HANSON CEMENT WORKS - PADESWOOD LANDFILL SITE

Landfill Closure Report

Report Number 1419741.501/A.0

Figure 1: Drift Groundwater Elevation Hydrograph

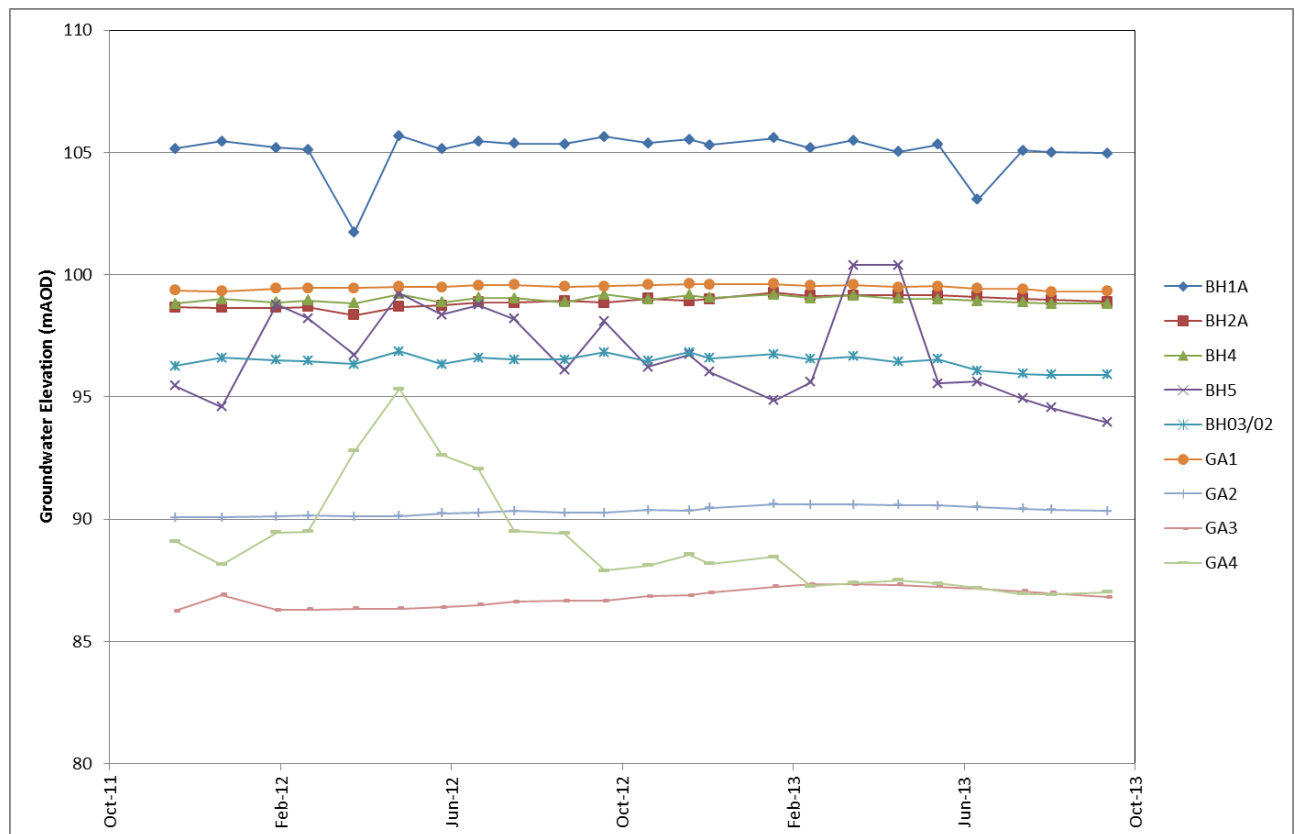
NRW Query: It is stated in the letter that GA1 is acting like a sump, but a sump for what, water level or water quality? This borehole (from the two contour plots) has the highest water level elevation (excluding BH1A – not marked on map, but included in Figure 1), implying that it is upgradient. We accept that the water levels are similar to the surface water level at this location, which potentially indicates that GA1 is hydraulically connected to the surface water, Please explain the reasoning behind this borehole acting as a sump – where does the water drain to?

- *The elevation of groundwater at GA1 is broadly co-incident with an interpolation of the elevation of the bed of the adjacent watercourse. From Figure 1 the elevation of groundwater in GA1 is observed to be relatively constant at between 99.31 and 99.63 mAOD, this elevation is also broadly co-incident with the elevation of*

Figure 2: Time-Series Graphs of Compliance Substances

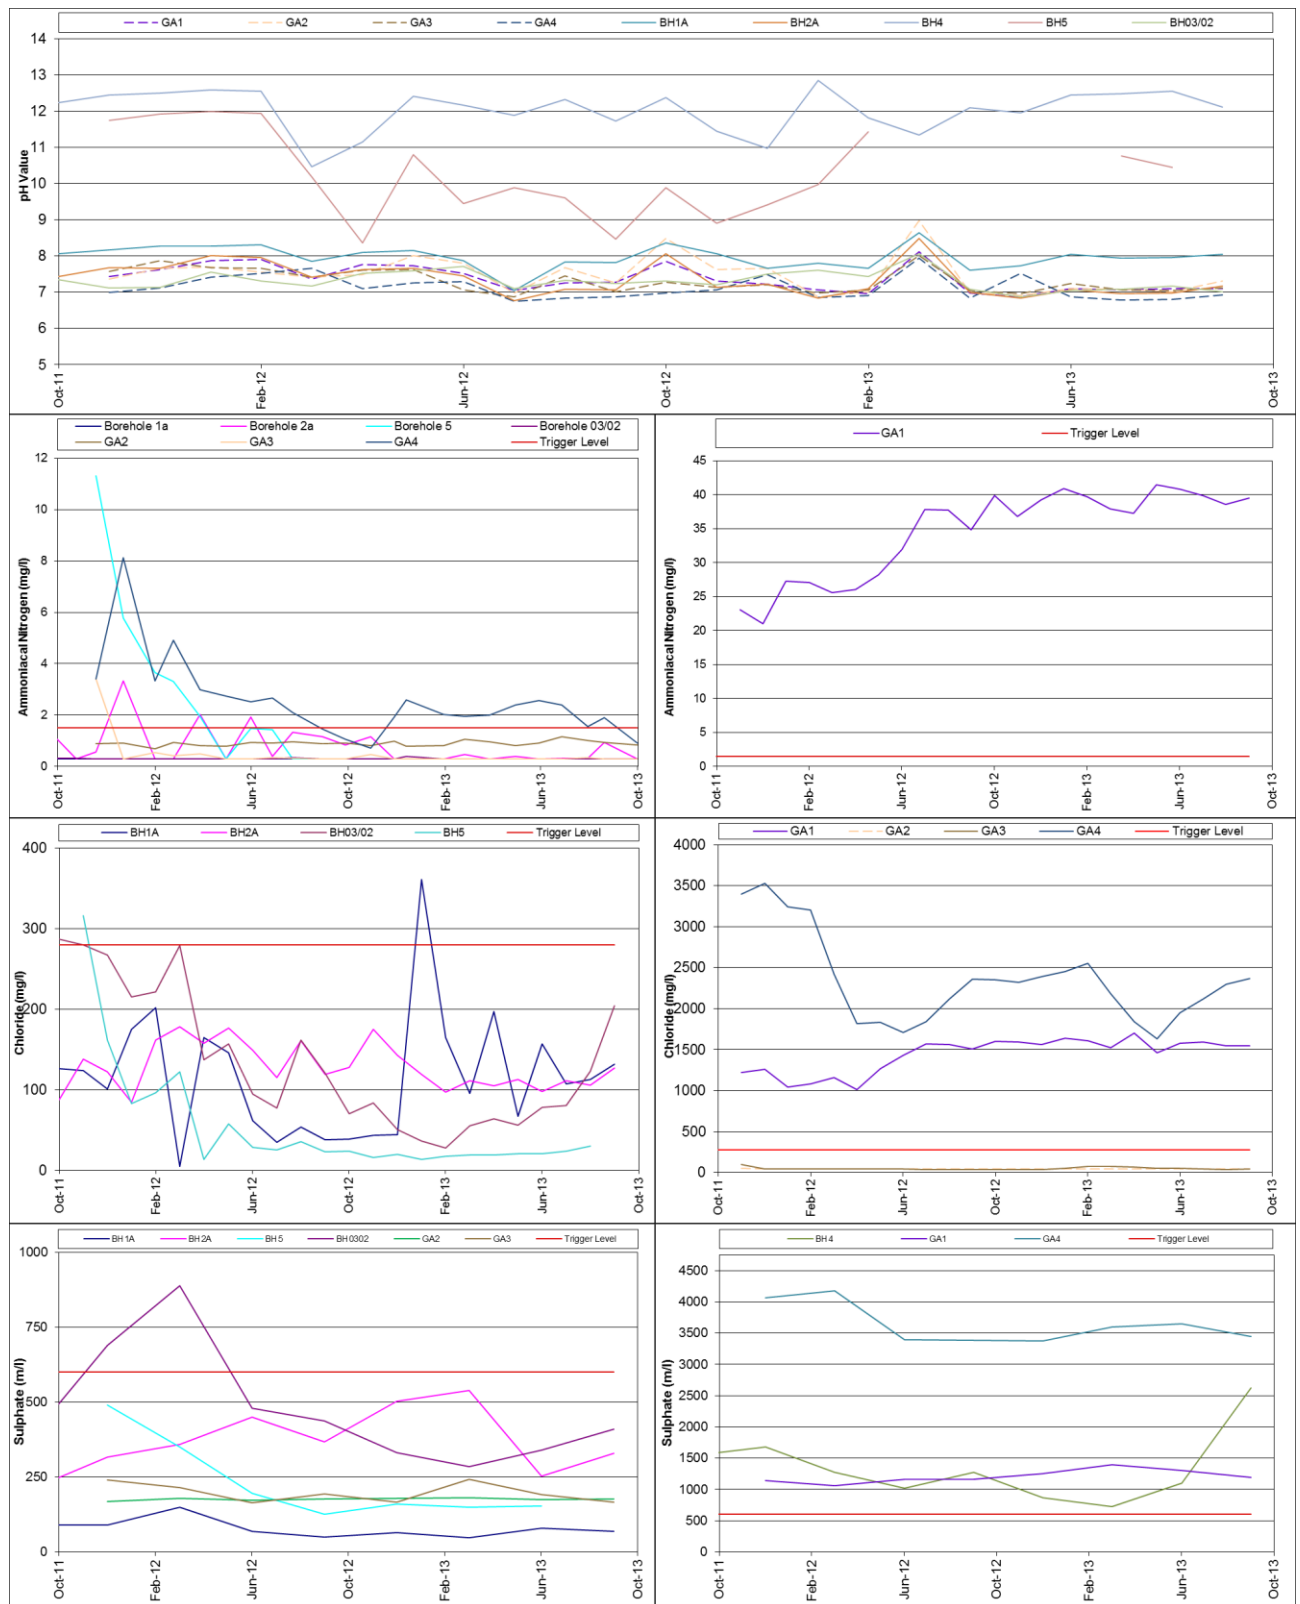
NRW Query: From Figure 2, GA1 and GA4 exceed the interim trigger levels for ammoniacal nitrogen, chloride and sulphate by a considerable amount for chloride and sulphate (orders of magnitude). GA1 is adjacent to the watercourse on the eastern flank and GA4 is on the western flank, downgradient of the site and below the bed level of the water courses. If GA4 has elevated contamination from the landfill and not adjacent to a watercourse (into which it could discharge as inferred at GA1) where is the contamination going – off site, on the pathway to deeper groundwater?
